Browns Ferry Nuclear Plant, Unit 1
Renewed Facility Operating License No. DPR-33
NRC Docket No. 50-259

Subject: **Browns Ferry Nuclear Plant (BFN), Unit 1 - Application to Modify
Technical Specification 3.4.9, "RCS Pressure and Temperature (P/T)
Limits" (BFN TS-484)**

**BFN 13-484, Browns Ferry Nuclear Plant (BFN), Unit 1, Application to Modify Technical
Specification 3.4.9, "RCS Pressure and Temperature (P/T) Limits"**

Figure 3.4.9-1
Pressure/Temperature Limits for
Mechanical Heatup, Cooldown following Shutdown, and
Reactor Critical Operations

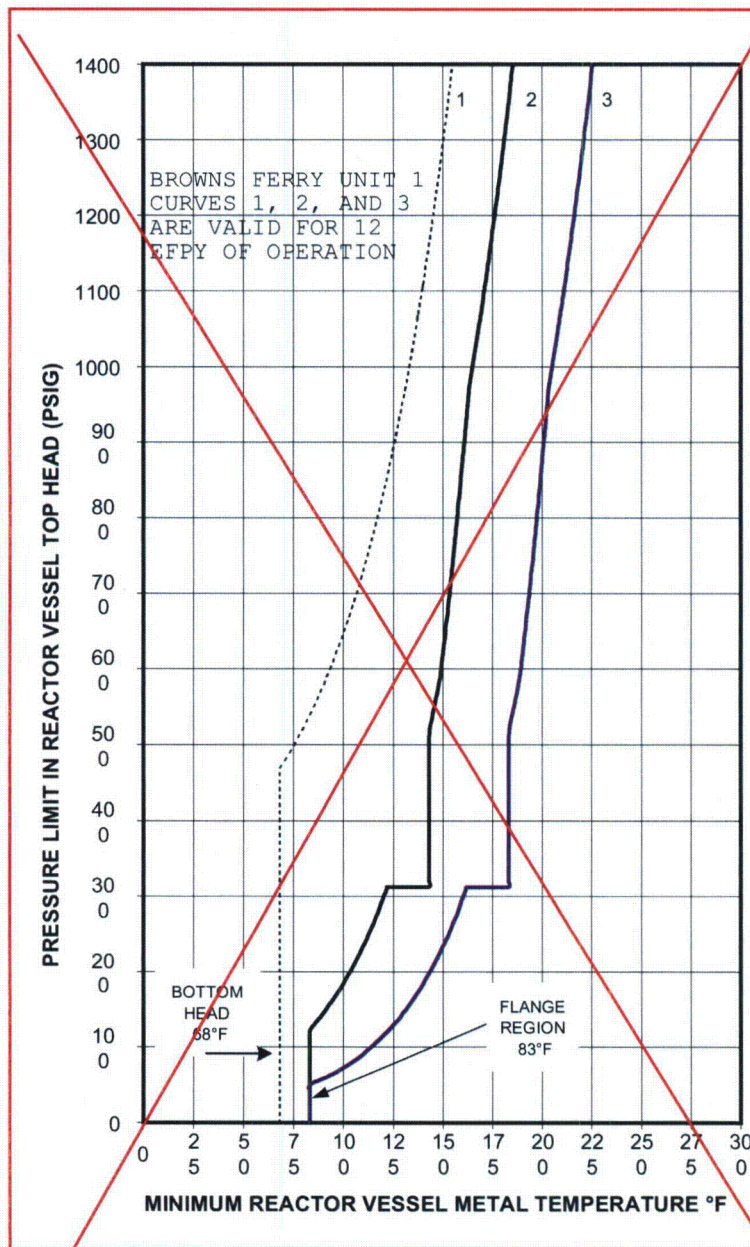
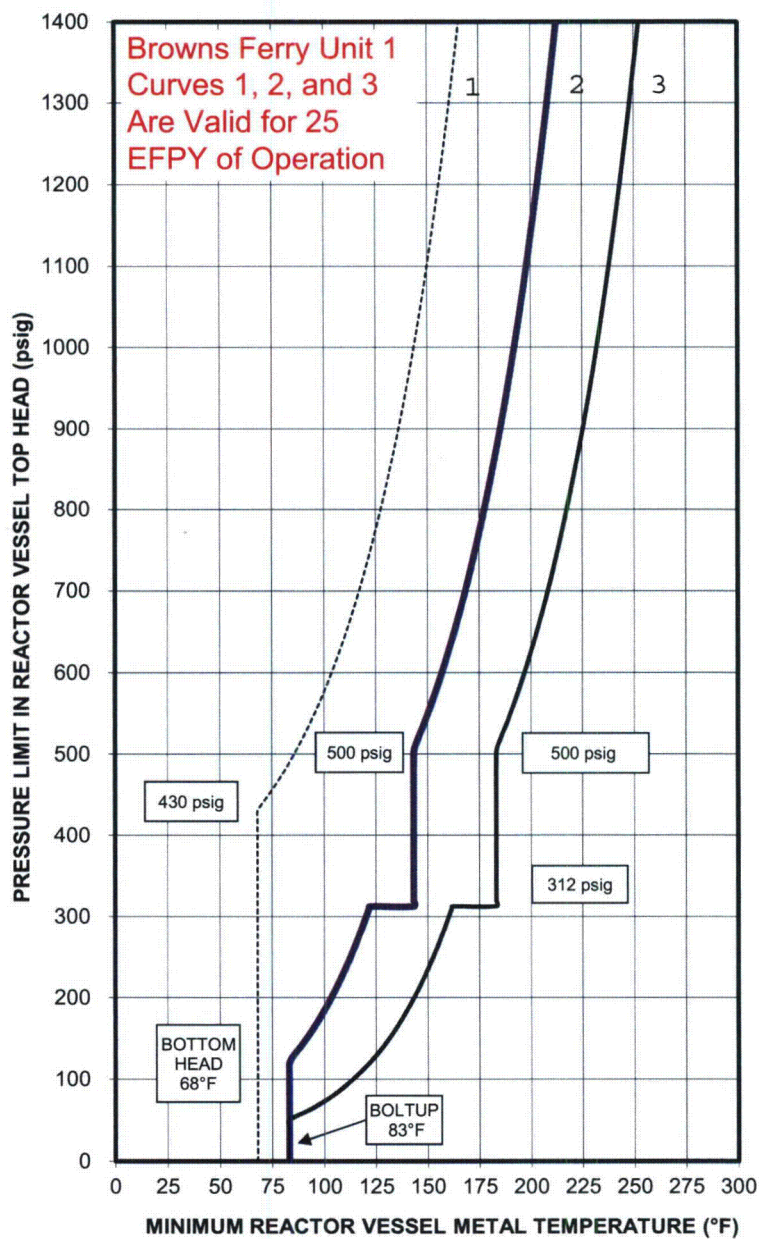
Notes
These curves include
sufficient margin to
provide protection
against feedwater
nozzle degradation.
The curves allow for
shifts in RT_{NDT} of the
Reactor vessel beltline
materials, in
accordance with Reg.
Guide 1.99 Rev. 2 to
compensate for
radiation embrittlement
for ± 2 EFPY.

Replace with Insert 1

Insert 1

Figure 3.4.9-2
Pressure/Temperature Limits for
Reactor In-Service Leak and Hydrostatic Testing

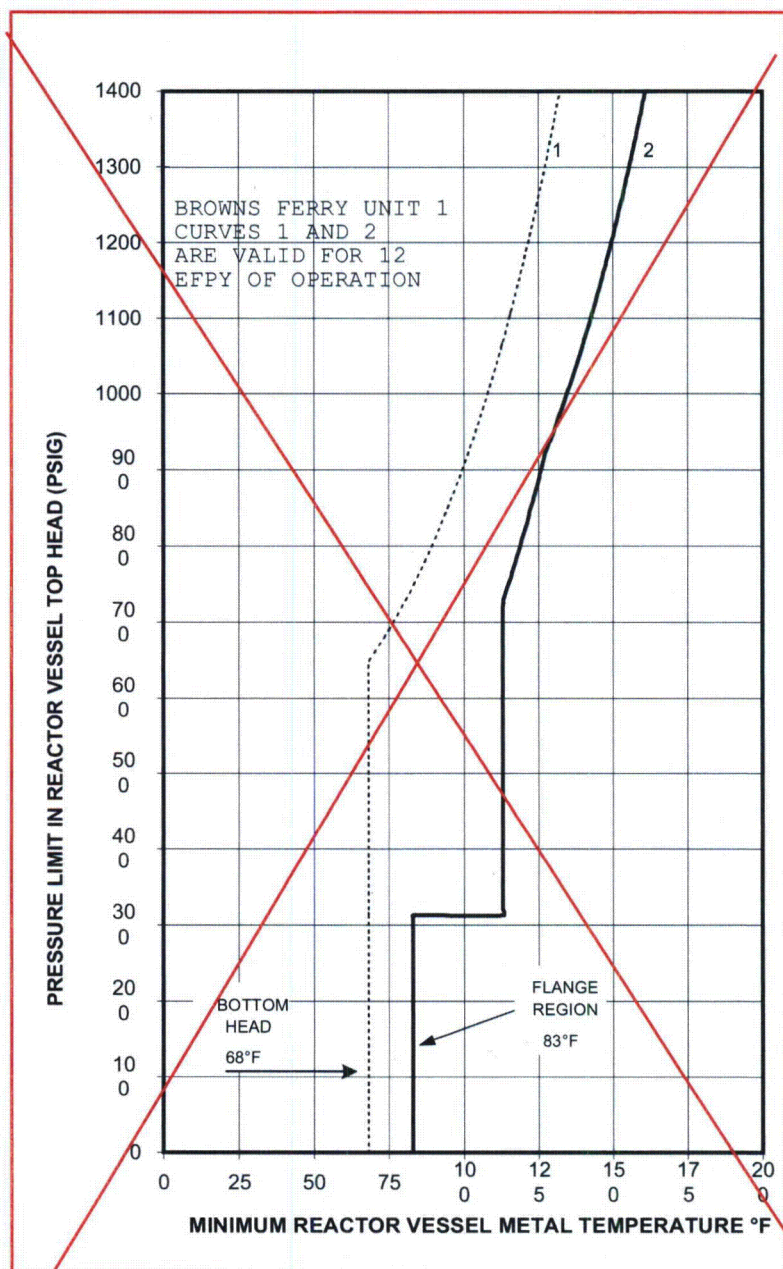
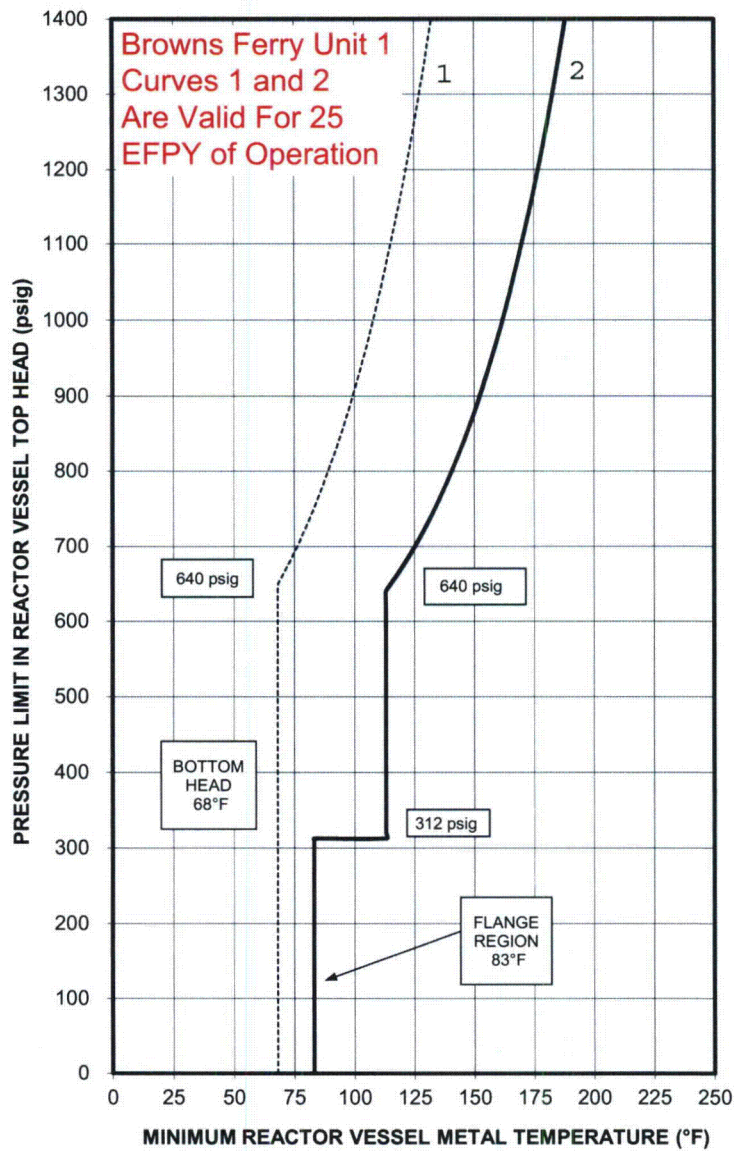
Notes
These curves include
sufficient margin to
provide protection
against feedwater
nozzle degradation.
The curves allow for
shifts in RT_{NDT} of the
Reactor vessel beltline
materials, in
accordance with Reg.
Guide 1.99 Rev. 2 to
compensate for
radiation embrittlement
for 12 EFPY.

25
The acceptable area for
operation is to the
right of the applicable
curves.

Replace with Insert 2

Insert 2

**Figure 3.4.9-1
Pressure/Temperature Limits for
Mechanical Heatup, Cooldown following Shutdown, and
Reactor Critical Operations**

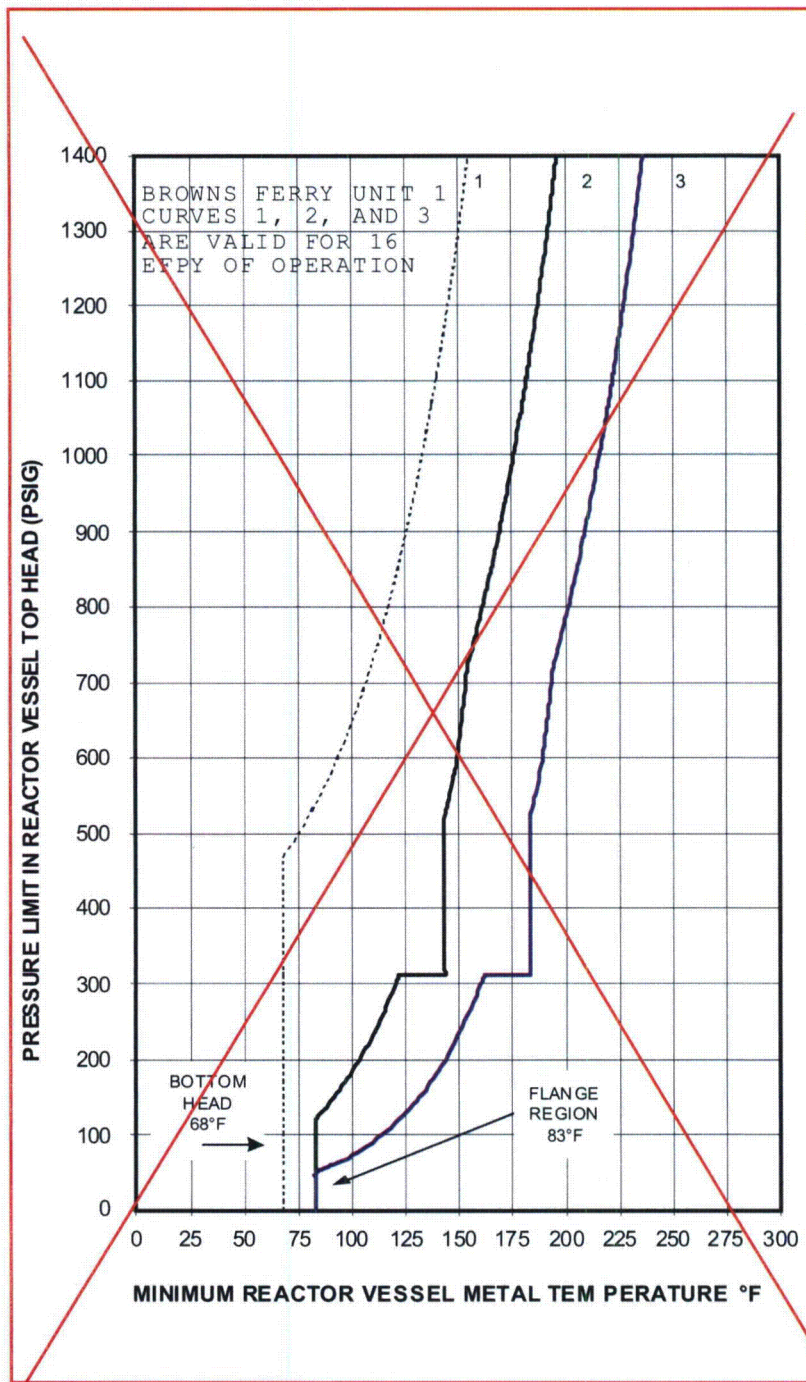
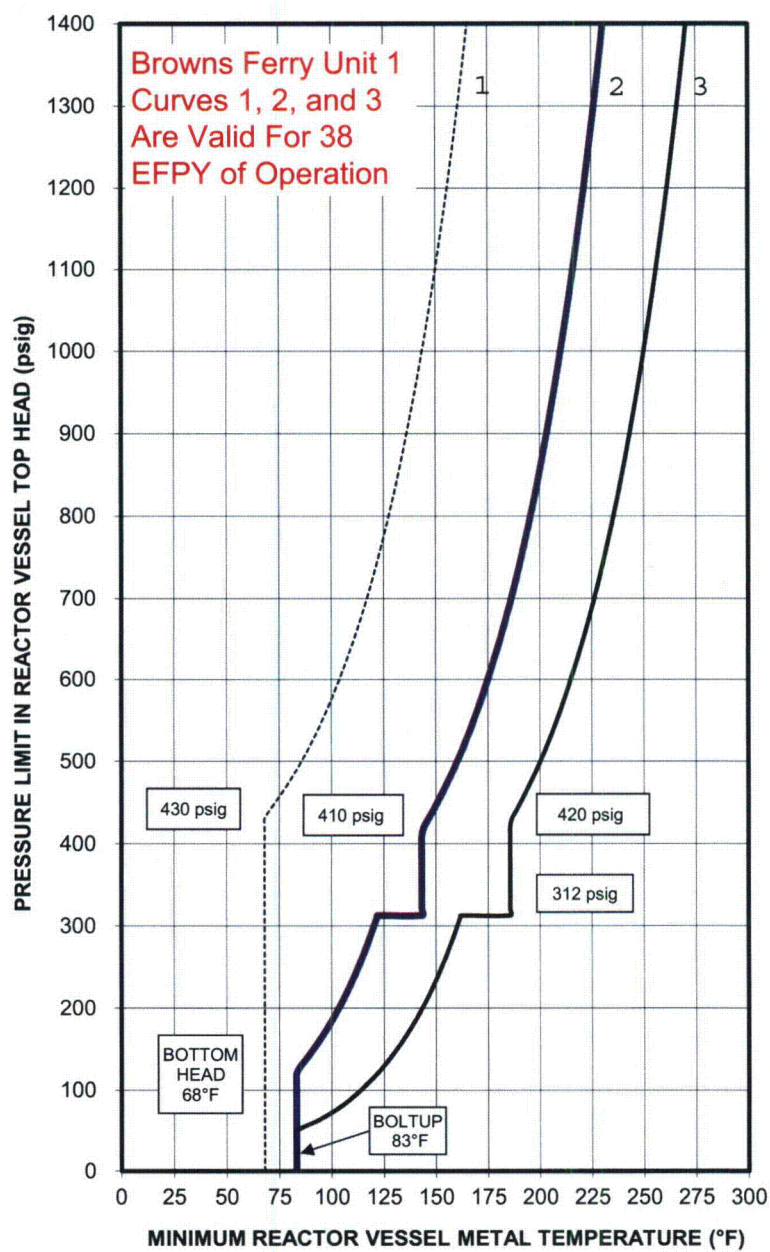
Notes
These curves include sufficient margin to provide protection against feedwater nozzle degradation. The curves allow for shifts in R_{NDT} of the Reactor vessel beltline materials, in accordance with Reg. Guide 1.99 Rev. 2 to compensate for radiation embrittlement for 16 EFPY.

38
The acceptable area for operation is to the right of the applicable curves.

Replace with Insert 3

Insert 3

**Figure 3.4.9-2
Pressure/Temperature Limits for
Reactor In-Service Leak and Hydrostatic Testing**

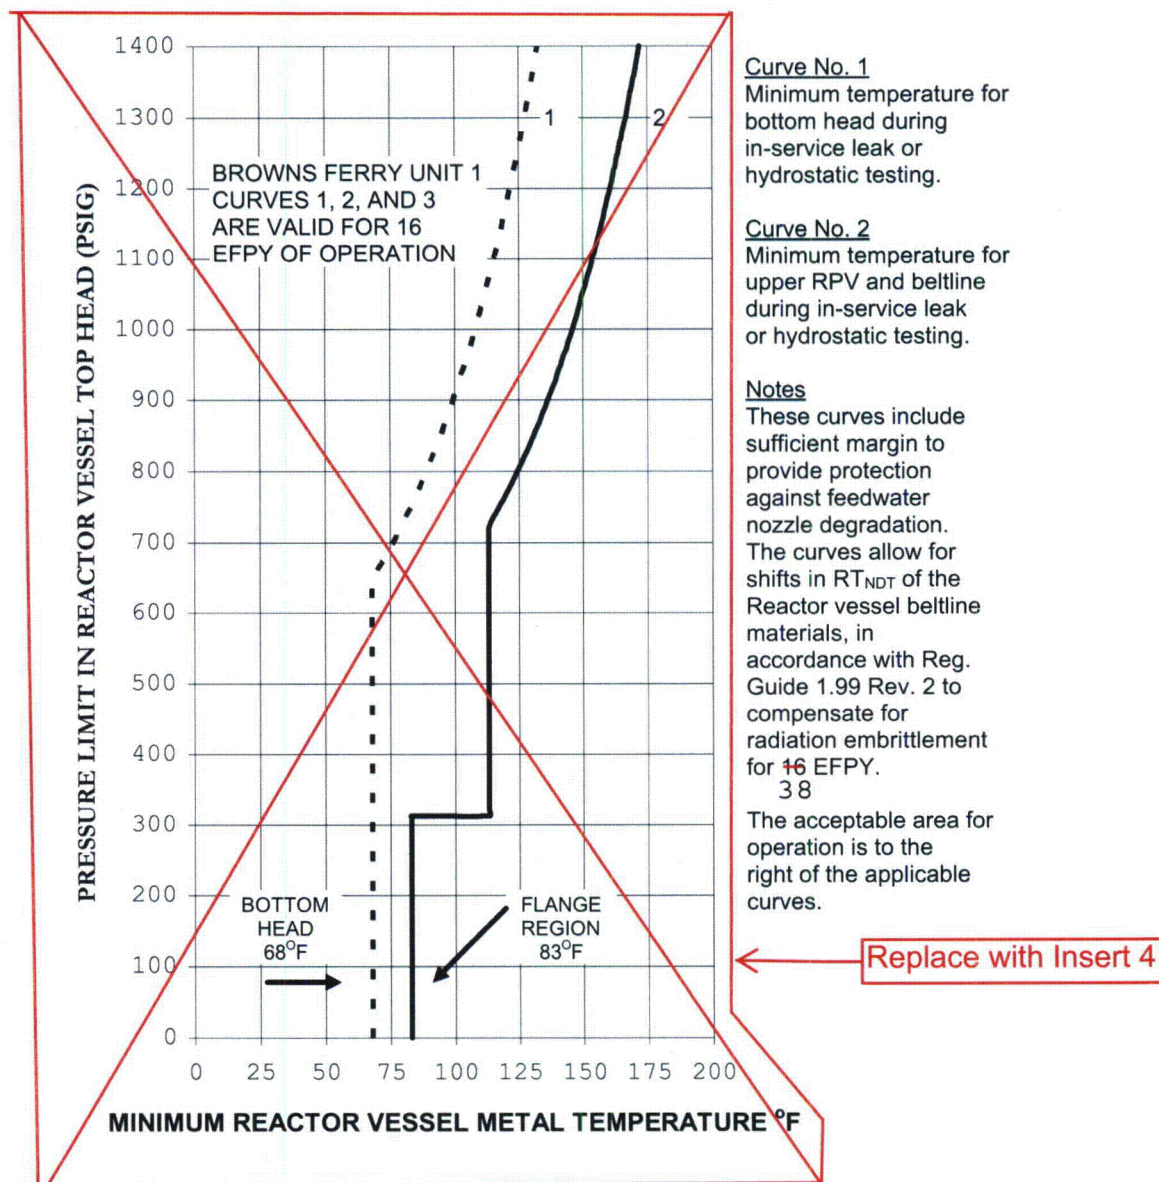
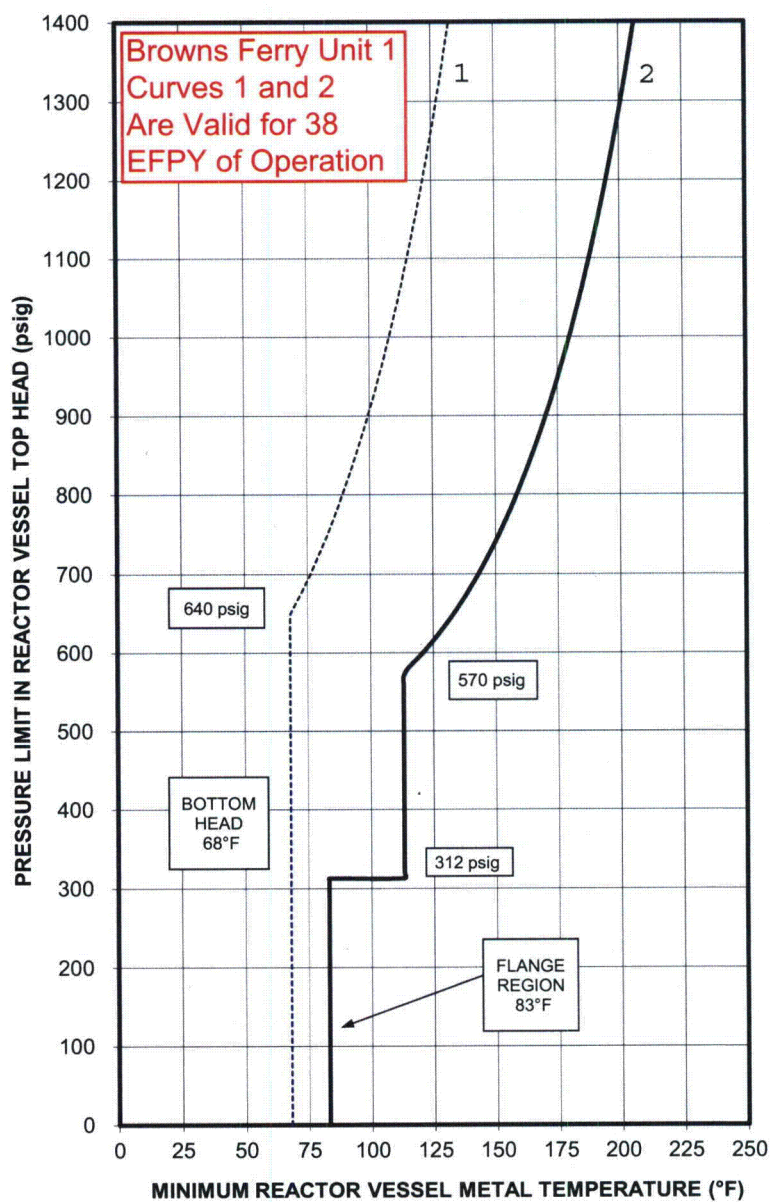
TVA proposes to delete and replace TS Figures 3.4.9-1 and 3.4.9-2 that are applicable for operations up to 12 EFPY and for operations > 12 EFPY and ≤ 16 EFPY, respectively, with new TS Figures 3.4.9-1 and 3.4.9-2 that are applicable for operations up to 25 EFPY and for operations > 25 EFPY and ≤ 38 EFPY, respectively.

In addition, an associated note for each figure is changed to reflect the new operational applicability limit with respect to EFPY.

Insert 4
